TOWN OF YORKTOWN PLANNING BOARD

PUBLIC MEETING AGENDA YORKTOWN TOWN HALL BOARD ROOM 363 Underhill Avenue, Yorktown Heights, NY 10598

July 12, 2021
7:00 PM

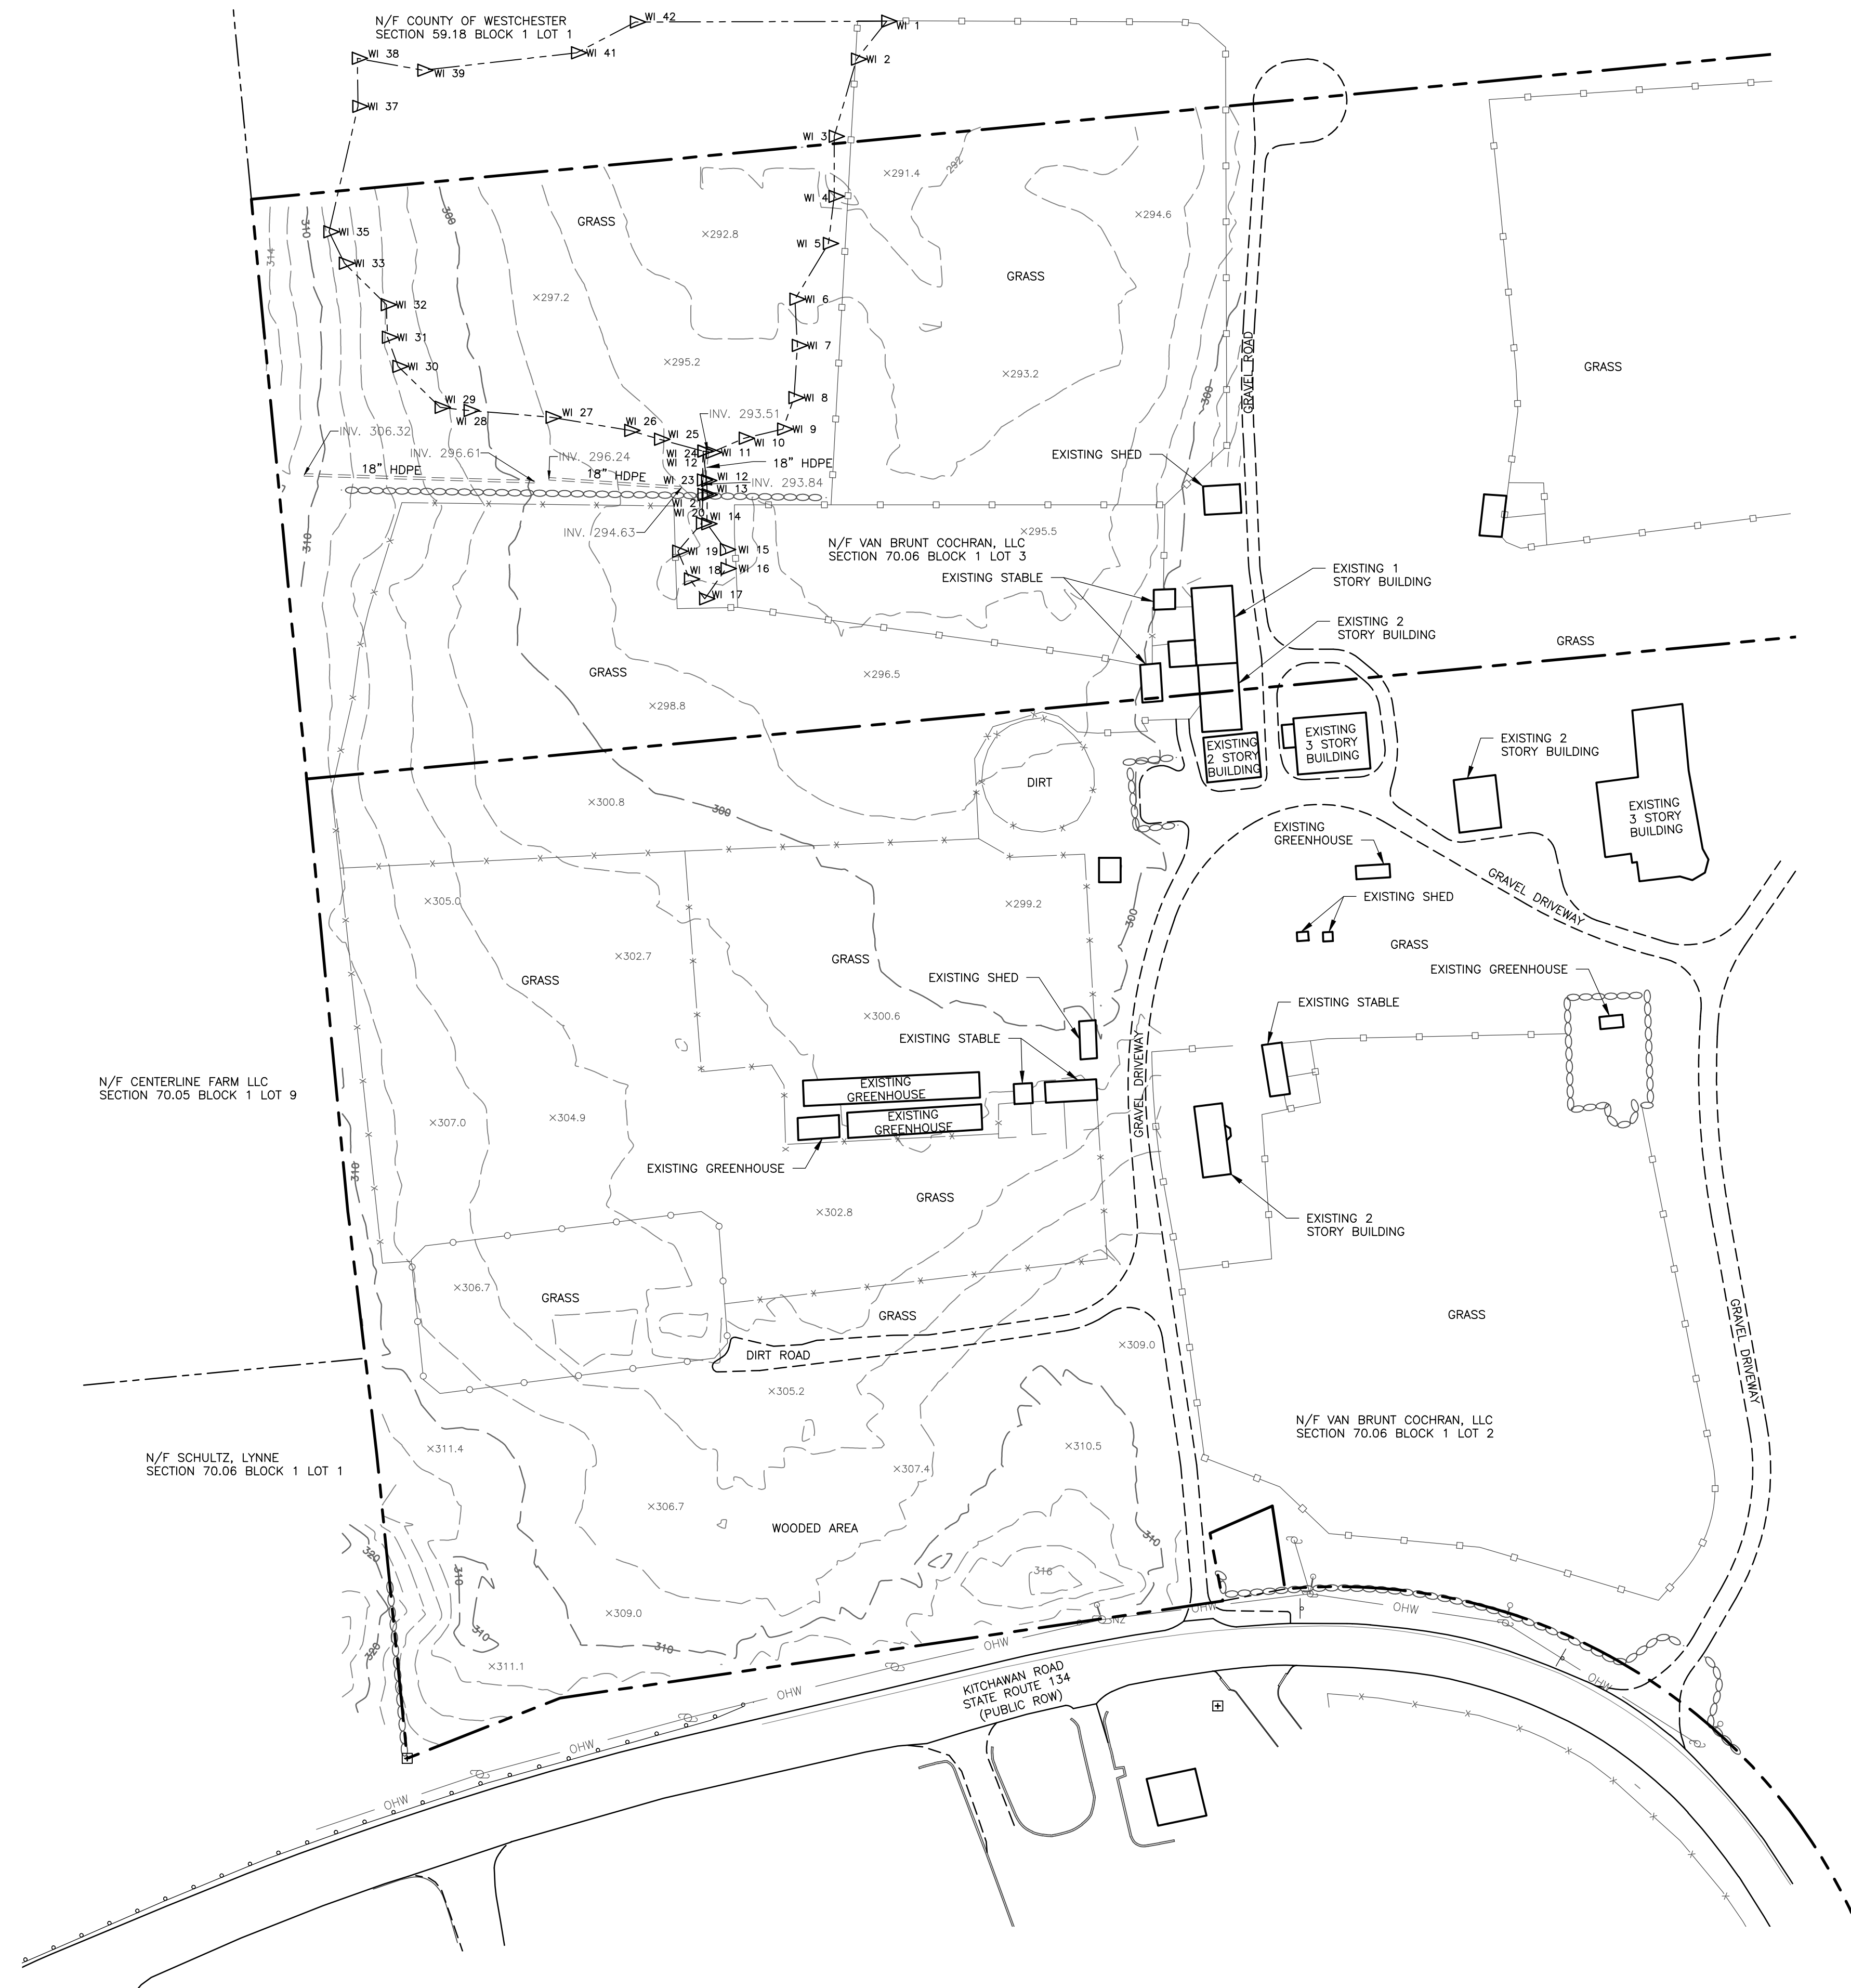
Upon review of the memorandum sent from the Conservation Board to the Planning Board on May 6, 2021 for the Kitchawan Farm Solar Farm project, we noticed discrepancies regarding the tree removal that I would like to clarify. On the site plan submitted for review, we had marked an 80ft wide area of trees to be removed to the south of the proposed solar array. That area is referenced in the memorandum. However, the actual area of tree removal is larger and includes trees that will be removed within the array area. The total area of tree removal on the south of the property is approximately 150ft wide, 75,000 sq ft. We want to be fully transparent and ensure our site plan was not misleading so let me know if there are any questions about this.

Another note is that the tree area on the south is not a mature natural forest as mentioned in the memorandum. In actuality, those trees are mostly unmanaged magnolias which used to be part of a nursery that is no longer used. The trees in that area were deliberately planted but are now an overgrown nursery area of overcrowded trees with an understory of predominantly invasive species.

- This array will be placed on a mostly open field. However, the development will have an impact on the southern section of the site. Applicant is retaining a wooden buffer for screening but there will be extensive removal of natural forest to accommodate the arrays. An eighty-foot wide band of mature natural forest will be removed. The Conservation Board recommends reducing the amount of arrays along the southern part of the site to limit the removal of the trees and disturbance to the natural area.
- The Board requests to review the planting plan when it comes available and encourages the use of native material when developing the plan.
- The Conservation Board looks forward to a site visit as soon as possible.
